# ***SAN JOAQUIN ENERGY CONSULTANTS, INC.***

**SUBJECT:   Underground Injection Control (UIC) Permit Application, Elk Hills Power Plant  
              Permit No. CA200002  
              Environmental Protection Agency (EPA) Technical Review**

The following comments address the need for additional information on the UIC Permit Application for the proposed Elk Hills Power Plant, as discussed in your technical review letter of February 23, 2000, to Mr. Donald E. Romine of Elk Hills Power, LLC. The comments correspond to the items as numbered in the technical review letter.

# GEOLOGIC MAP OF THE 7G/18G PW DISPOSAL AREA, SOUTH FLANK NPR-1

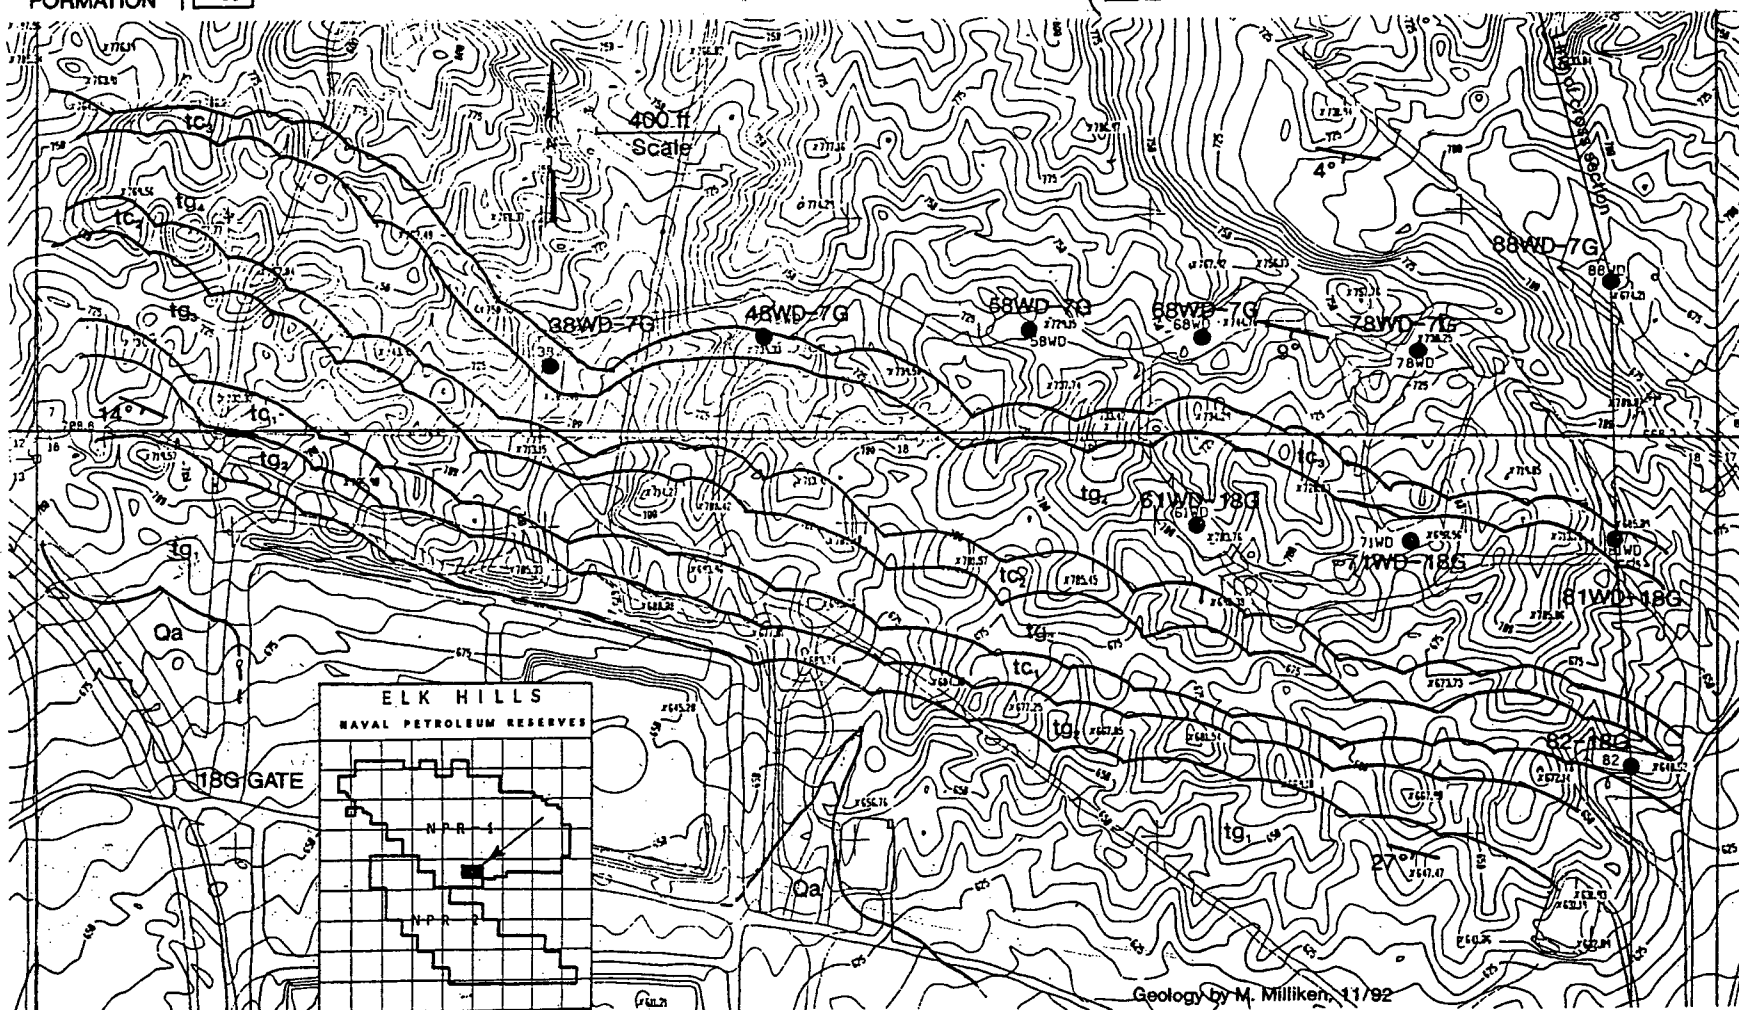
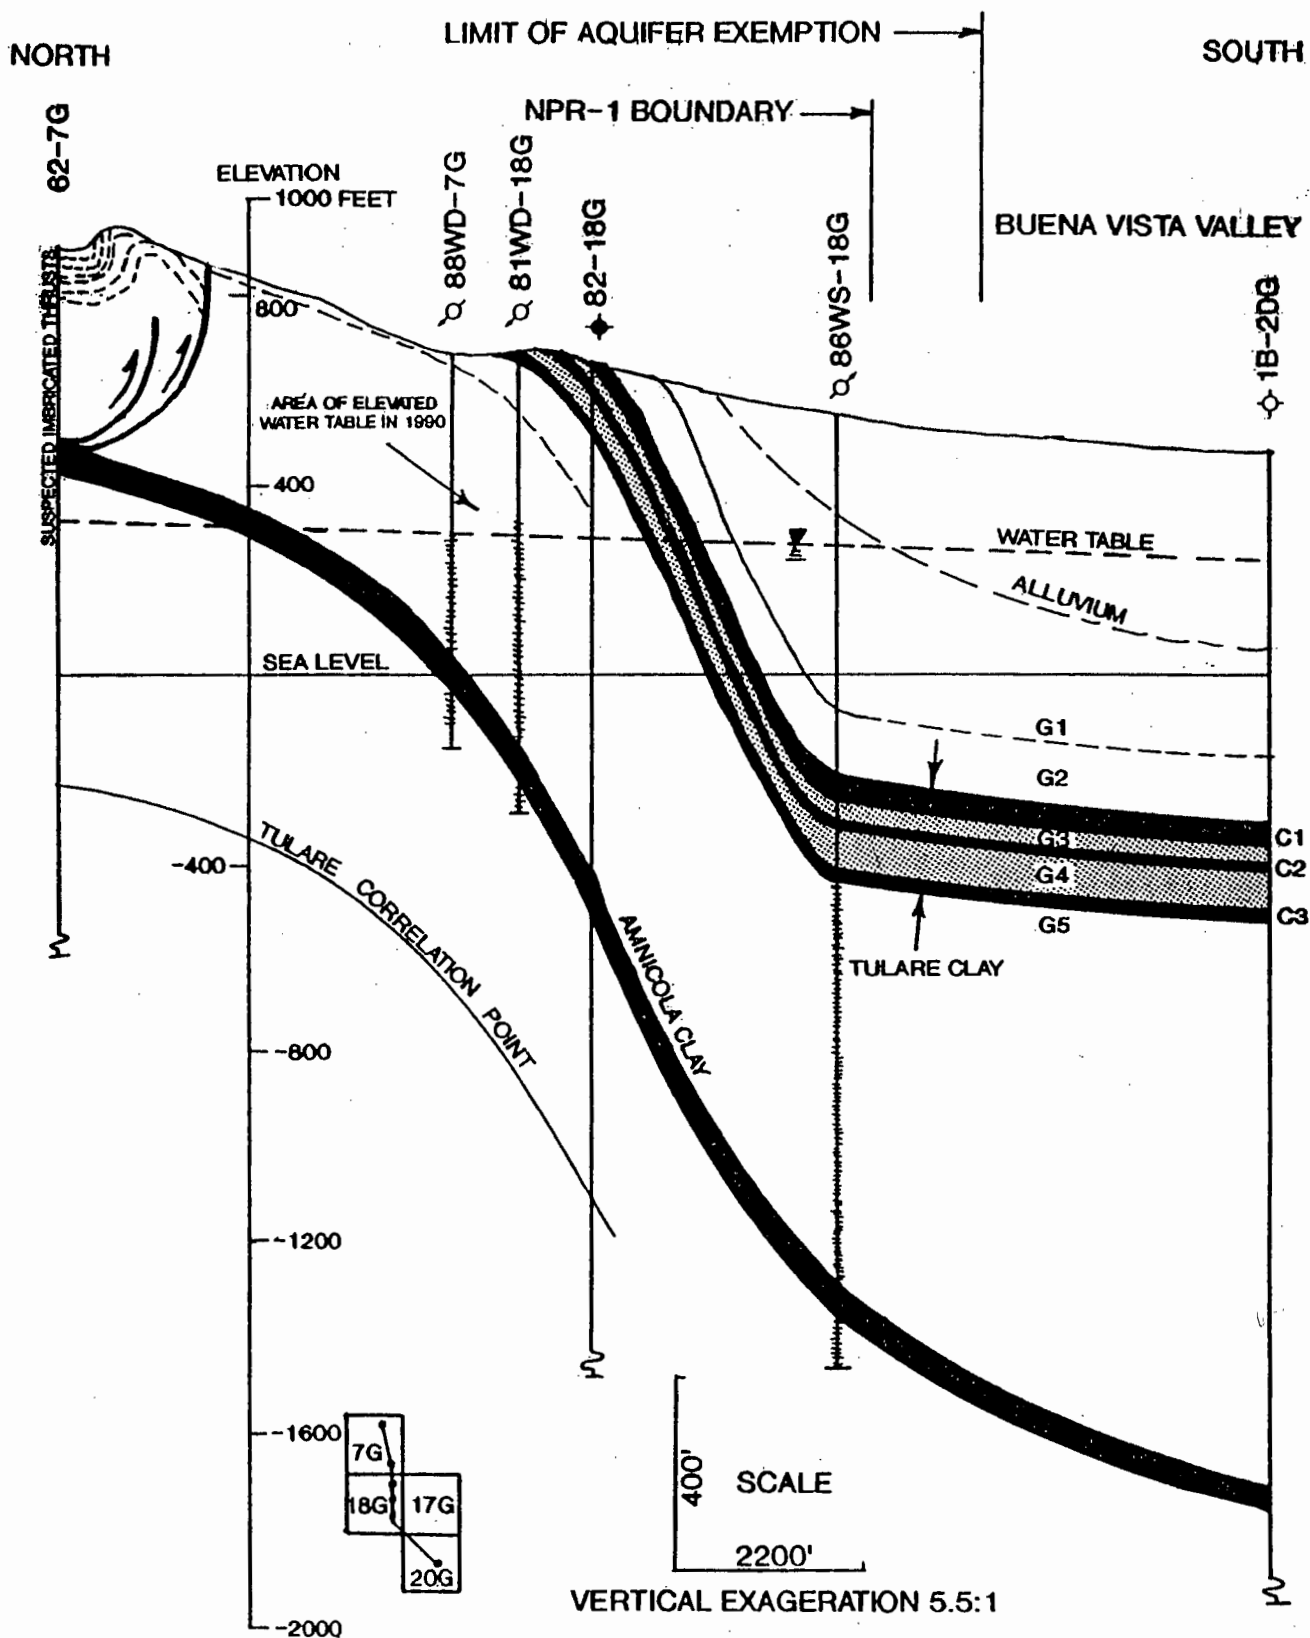
- B) **Outcrop of Tulare injection zone:** The outcrop of the Tulare injection zone was mapped by Milliken (1992) and is included as Attachment D. The Tulare injection zone crops out northward of the base of the unit mapped as "tc<sub>3</sub>". This outcrop is located about 3,300 ft north of the proposed injection wells, or about 2,300 ft outside of the area of influence. Based on the sensitivity calculations discussed in preceding Item 2.B.f, it is unlikely that the waste front would reach the outcrop area. Also, the area where the Tulare injection zone crops out is about 100 ft higher in elevation than the area of the proposed injection wells, and injection pressures are well below those required to surface at the outcrops. As discussed in Item 4.A of this letter, neither the waste front nor the pressure front calculations indicate that the injectate would reach the outcrop area. Finally, saturated Tulare clay has been documented as a groundwater barrier in the Elk Hills area (Milliken, 1992; Phillips, 1992; Milliken, 1993) and is expected to act as such in the area of the proposed injection wells.

Figure 1. Aerial photograph showing faults in the proposed EHPP disposal well field area.

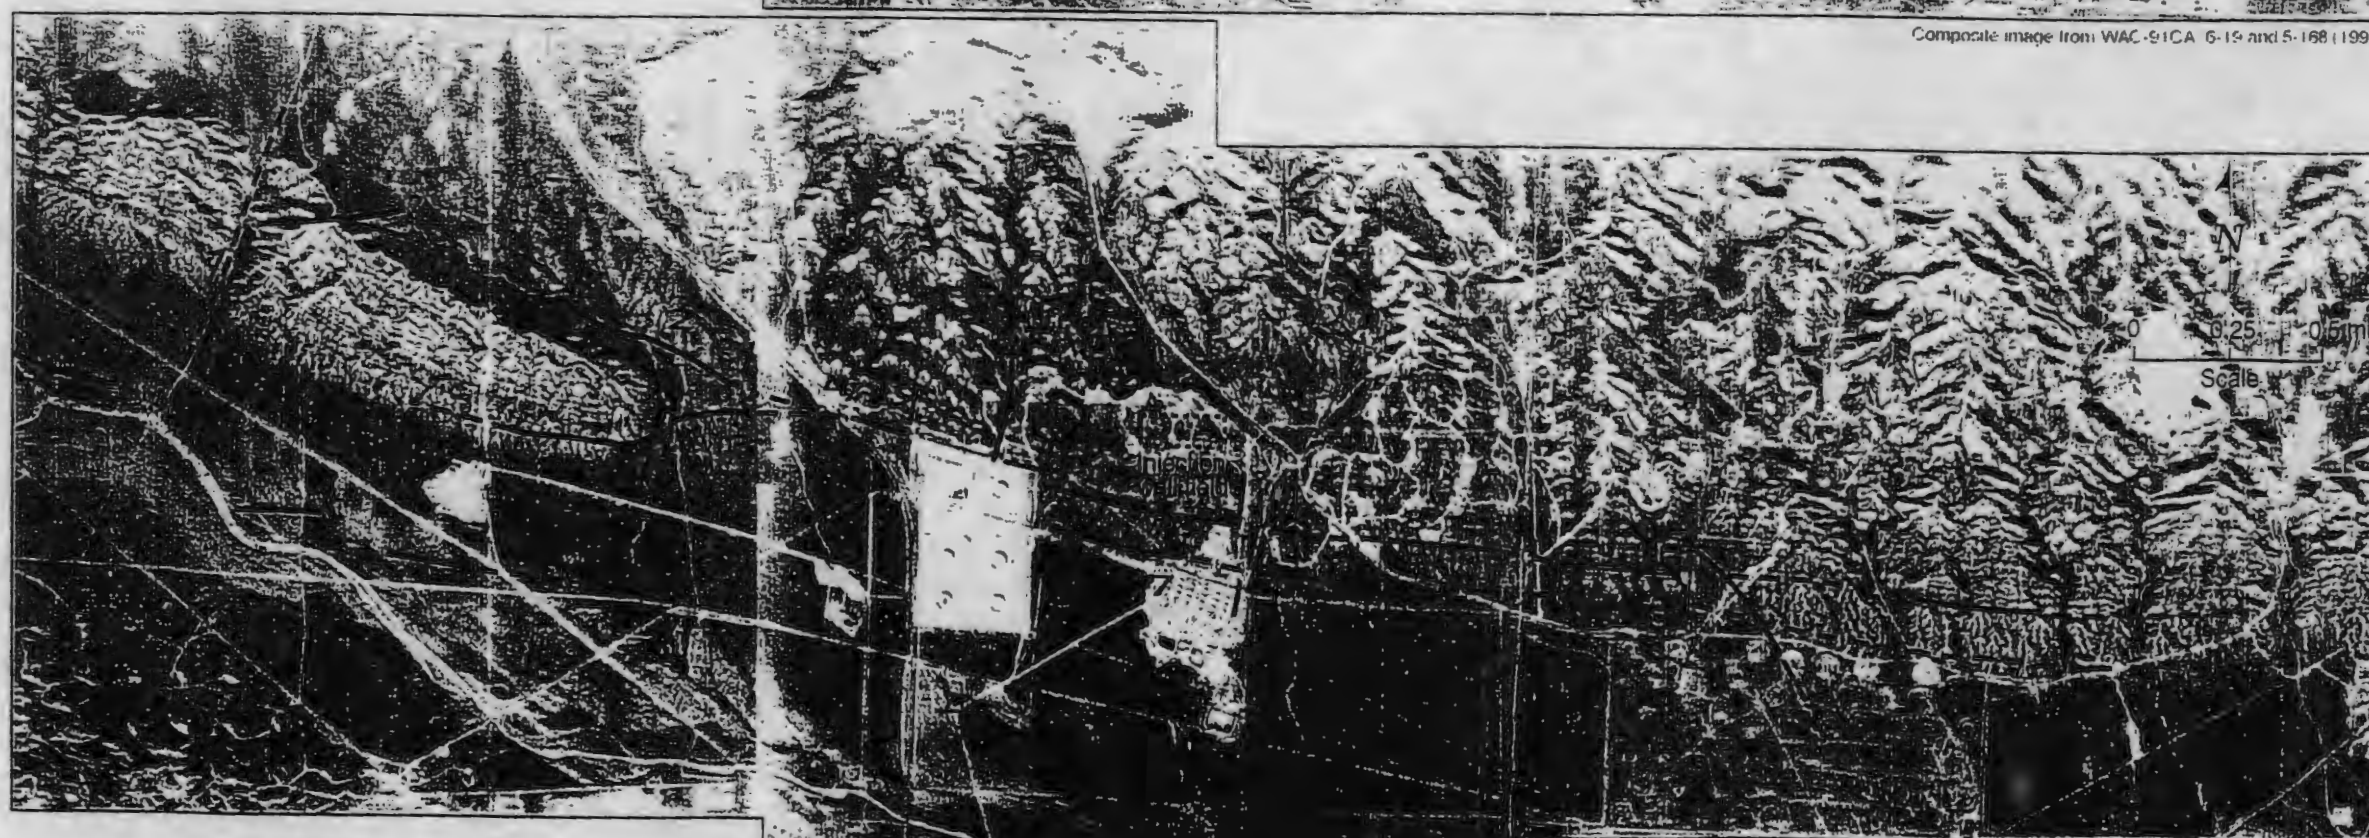
Response: Messrs. Bachhuber and Brankman based their interpretation of surface faulting on 1991 aerial photographs at a scale of 1:24,000, or 1 inch equals 2,000 feet. Four days of field reconnaissance, examination of stereographic pairs of aerial photographs from 1975 and 1981 (scales of 1:12,000, or 1 inch equals 1,000 feet, and 1:24,000, respectively), review of geologic reports (Milliken, 1992; Phillips, 1992) and geologic maps (Dibblee, 1971; Kern County Council of Governments, 1974; Smith, 1965) by San Joaquin Energy Consultants did not support the interpretation of surface features mapped by WLA as being faults. The features mapped as faults by WLA occurred along natural depositional contacts between different lithologies and/or linear cultural features, such as dirt roads, pipelines, or utility lines.

conclusion as San Joaquin Energy Consultants, which was that there was no observed evidence of surface faults as mapped by WLA in its Figure 1.
